## Reviewer #1: Melody Sandells

This paper demonstrates (mostly) an improvement in simulated SWE from assimilation of synthetic observations derived from an active microwave sensor through an OSSE. The analysis is based on the difference between a calibrated nature run and uncalibrated open loop run, with an assessment of the effects of SWE retrieval and forest cover fraction limits for a fixed satellite orbit and error budget configuration (with extended error budget in the supplementary material). The analysis is performed over a region in Colorado over a range of elevations, vegetation densities and snow types. The paper is very well written and easy to follow, with some excellent visual representations of the results. As the authors highlight, the results depend on the assimilation system used and this complements the Garnaud et al. (2019) study well. The results are useful to demonstrate the necessary retrieval performances for the design of retrieval algorithms and as such is worthwhile for publication.

## **Reviewer #2: Anonymous Referee**

**Figure S3.** (a) an example of global daily TAT-C masked swath map and (b) examples of consequent five day TAT-C masked swath maps over the study domain

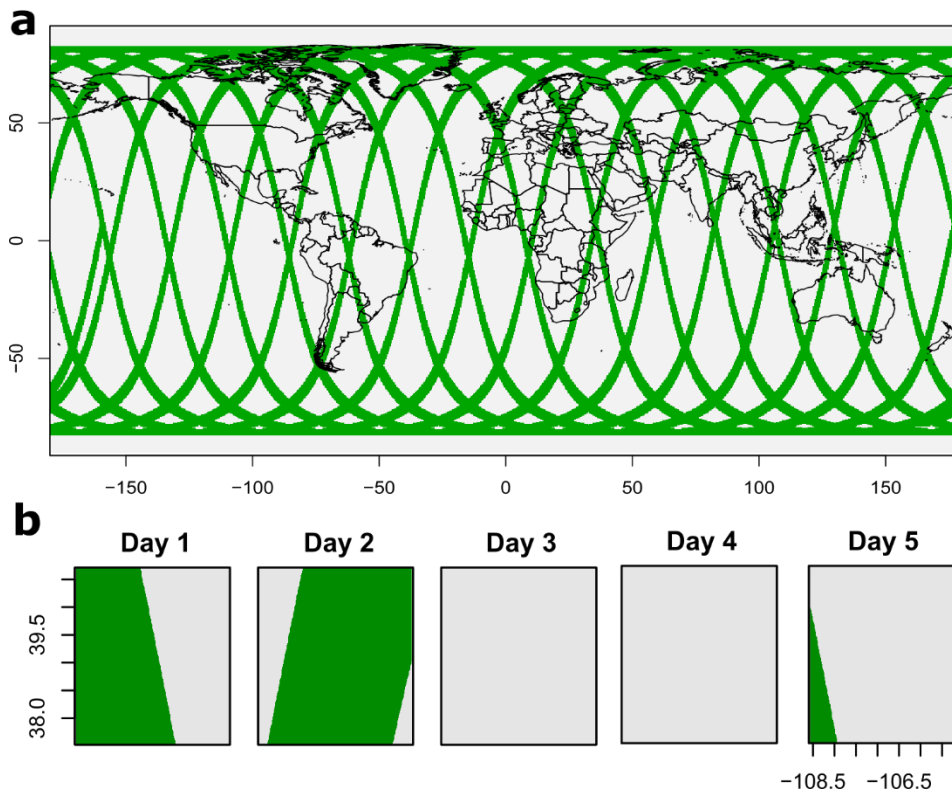
- Lines 215-222. A supplementary figure demonstrating the flow of TAT-C derivation of the swaths would be helpful

[Answer] Thank you for your suggestion. We added a figure showing the masked swath using TAT-C in Supporting Information (Figure S3).

“**Figure 9** Spatial mean values of temporal RMSEs and the improved percentages (%) between the 24 DA experiments and the Nature run (NR) with different levels of deep snow and tree cover fraction (TCF) detection limits relative to the Open loop (OL) simulation”

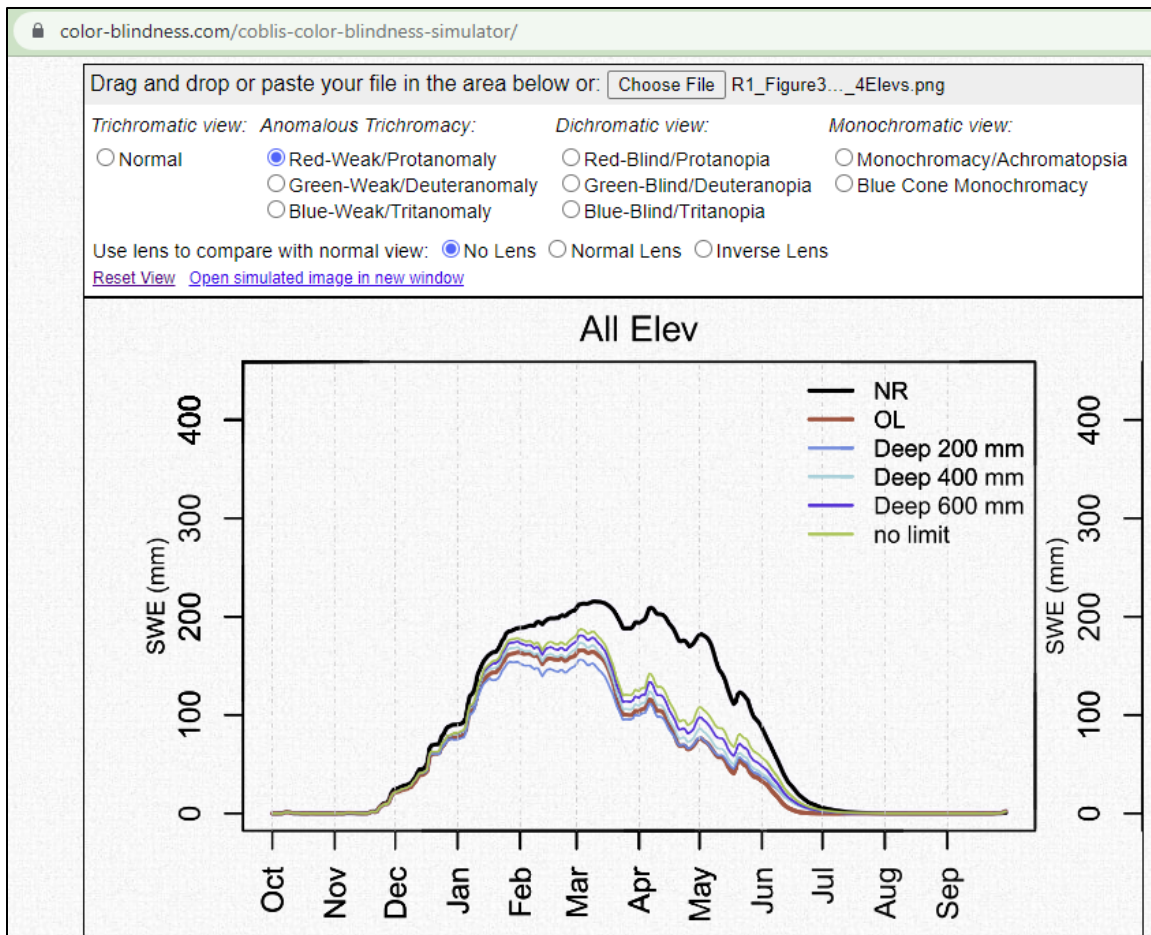
- Equation 1 gives temporal RMSE – please could you include the equation for spatial RMSE in Fig 9 or adapt this one?

[Answer] Fig 9 is the spatial mean of “temporal” RMSEs. To clarify, we edited the caption of the Figure 9.

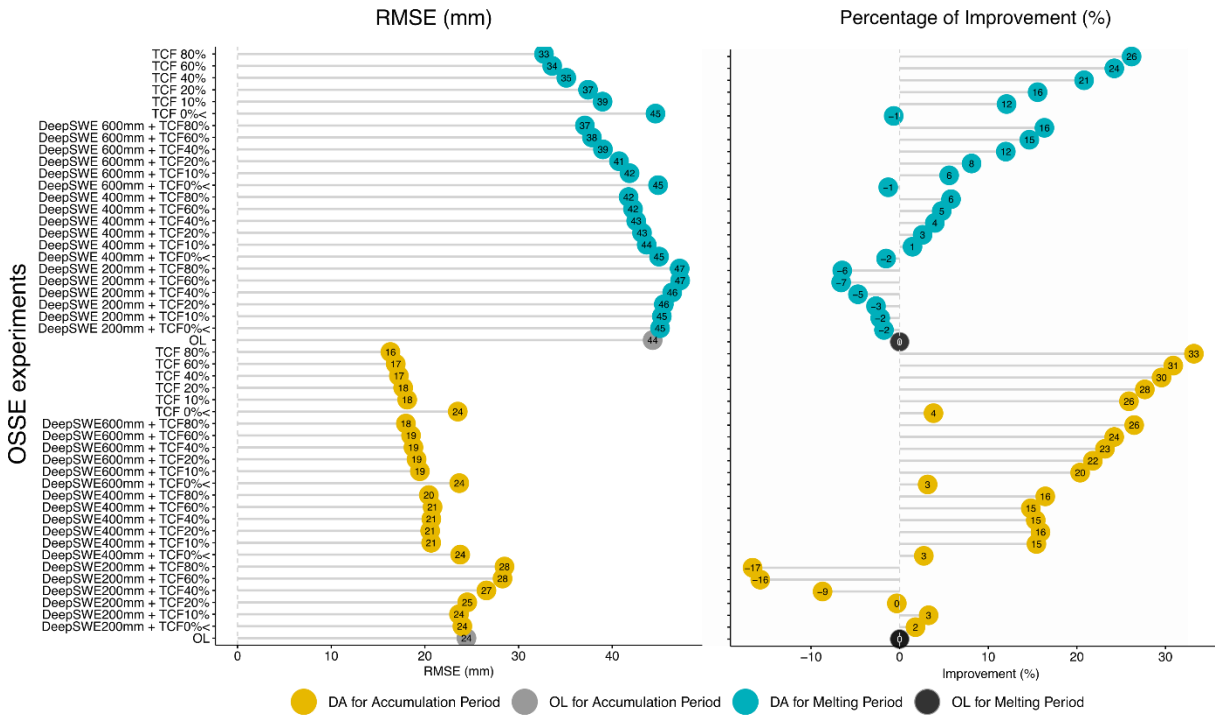
- Line 298-300. Please could you rephrase this? I think this is saying that the improvements come from better retrieval algorithms rather than the better spatial resolution with active, but I'm not sure.

[Answer] You understand correctly. I rephrased this to be clear.

This implies that even though a hypothetical mission can provide a finer spatial resolution SWE product (1 km) than existing passive microwave missions (e.g., 25 km), we could not achieve the better SWE estimates unless the hypothetical mission has better retrieval algorithms than that of passive microwave (e.g., 200 mm deep SWE limit and 20% of TCF).

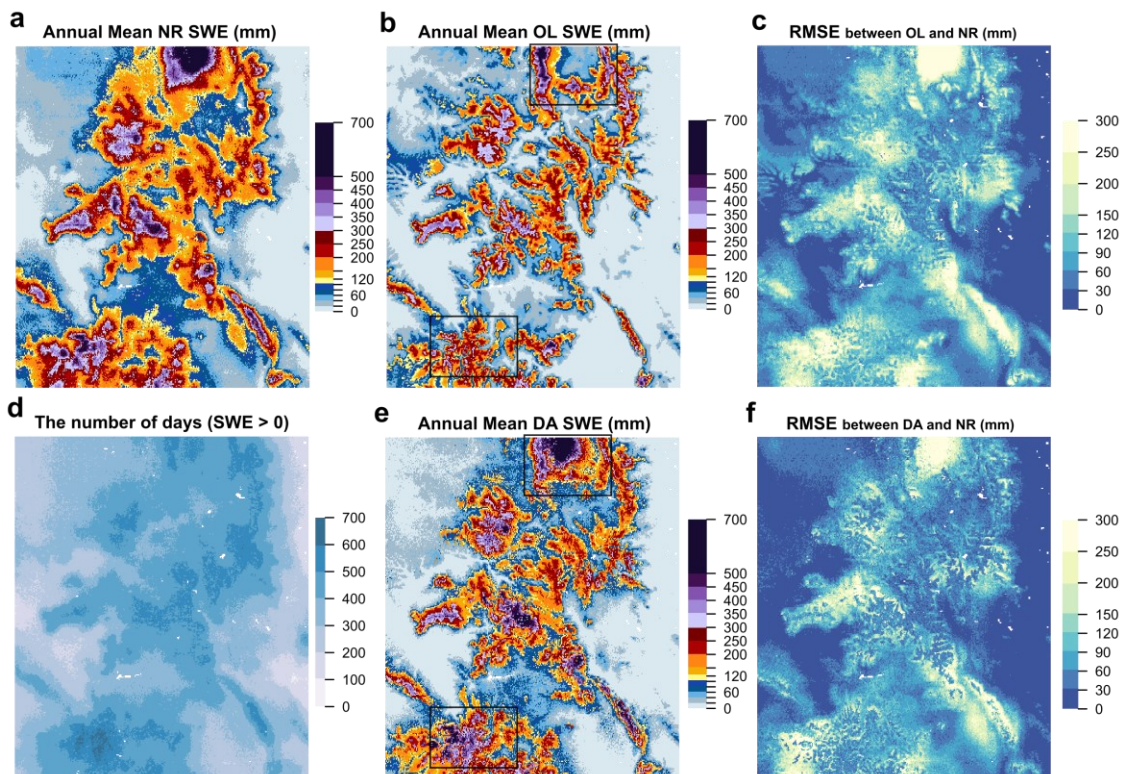
• Lines 316-317. Use boxes to draw attention to the regions in Figure 6.

[Answer] Thank you. I added them.

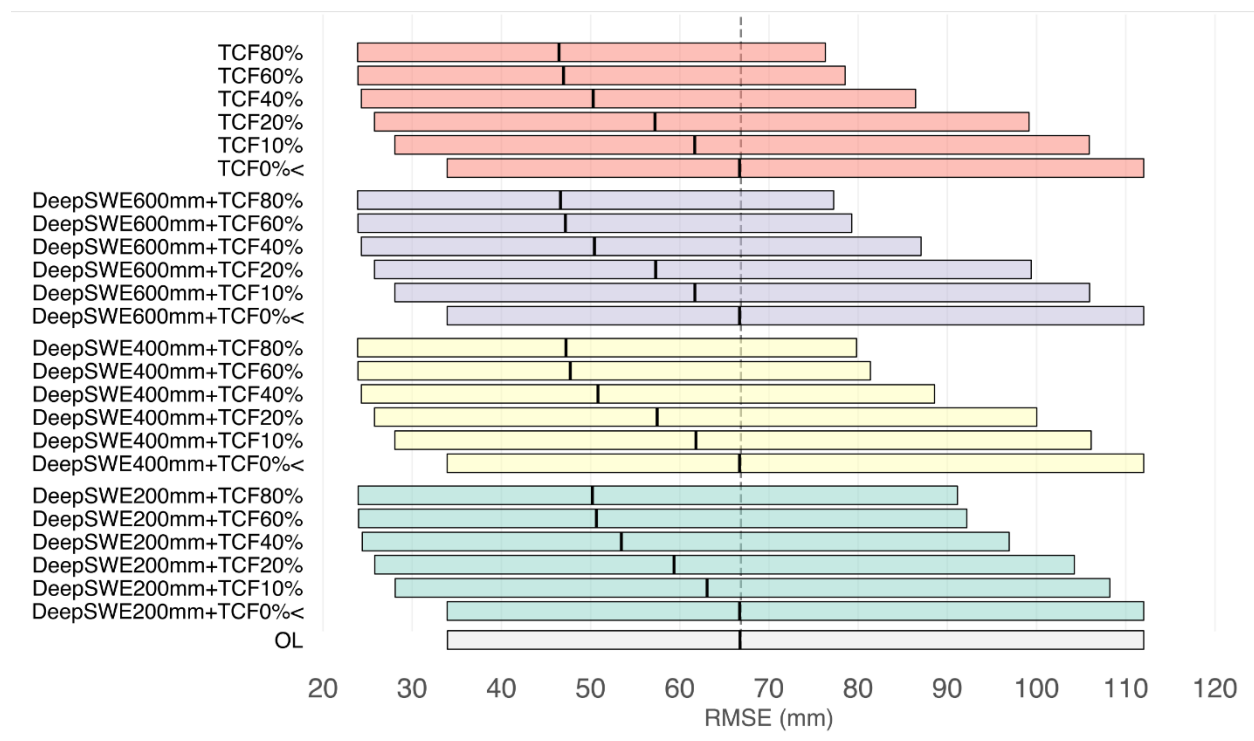
- Fig 6. These appear have a different ratio to Fig 1. Please make sure there are the same number of x,y pixels in both. There also appears to be some striping artefacts in Fig 6f (thin white vertical strips of 1-2 pixels) – what is causing this?

[Answer] Thank you for pointing out this. The striping artefacts were caused in the process of converting statistic values to the raster type. We've updated the figure (attached above).

RMSE between DA and NR

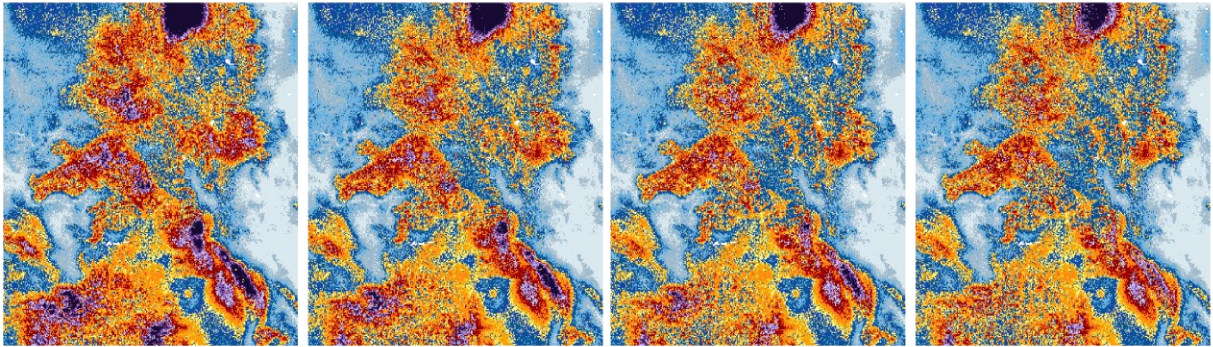
Fig 7.: Change RMSD to RMSE

[Answer] We changed this. Thank you.
